# Access Compliance Report

## Public Rights-of-Way

### (Curb Ramps)

Intersection ID: 10019976	Main Street: ARENA_BV	Cross Street: N/A	Location: NW
ADA ID: 3D829D1BA078	Ramp Type: PerpDiag	Initial Pass/Fail: Fail	Overall Compliance: No
		Severity Score: 12.5

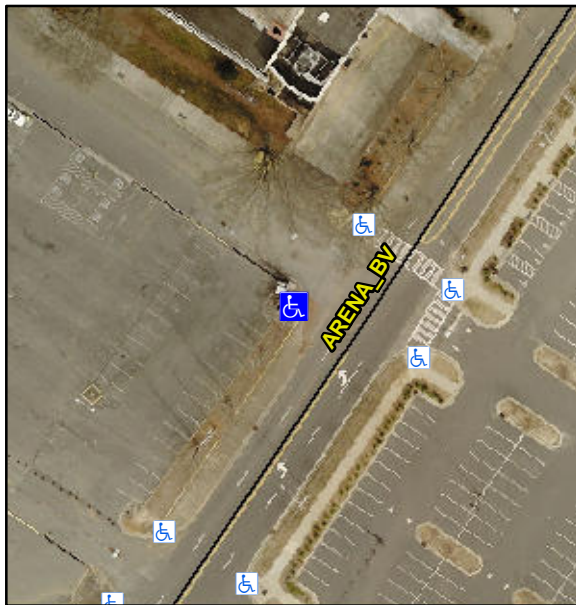
**Not Found, R304.2.2**

Compliance	Description	Data	Compliance	Description	Data
N/A	Ramp Length (in)	58.0	No	Ramp Slope (%)	11.7
Yes	Ramp Width (in)	96.0	Yes	Ramp XSlope (%)	1.9
N/A	Flare Type LT	N/A	N/A	Flare Type RT	N/A
N/A	Flare Slope LT (%)	N/A	N/A	Flare Slope RT (%)	N/A
N/A	Flare Traversable LT?	N/A	N/A	Flare Traversable RT?	N/A
N/A	Landing Length (in)	N/A	N/A	DWS Provided?	N/A
N/A	Landing Width (in)	N/A	N/A	DWS Contrast?	N/A
N/A	Landing Slope (%)	N/A	N/A	DWS Length (in)	N/A
N/A	Landing X Slope (%)	N/A	N/A	DWS Full Width?	N/A
N/A	Landing Curb? (Y/N)	N/A	N/A	DWS Offset (in)	N/A
N/A	Shared Landing?	N/A			
N/A	Gutter Ponding?	N/A	N/A	Gutter Slope (%)	N/A
N/A	Gutter Lip Ht (in)	N/A	N/A	Gutter X Slope (%)	N/A
N/A	Painted X Walk1?	No	N/A	Painted X Walk2?	No
	X Walk 1 Direction	To SE		X Walk 2 Direction	To NE
N/A	X Walk 1 Width (in)	N/A	N/A	X Walk 2 Width (in)	N/A
	X Walk 1 Slope (%)	1.7		X Walk 2 Slope (%)	3.1
	X Walk 1 X Slope (%)	2.8		X Walk 2 X Slope (%)	2.3

**Remove & Replace Curb Ramp With Two New Directional Ramps or Equivalent.**
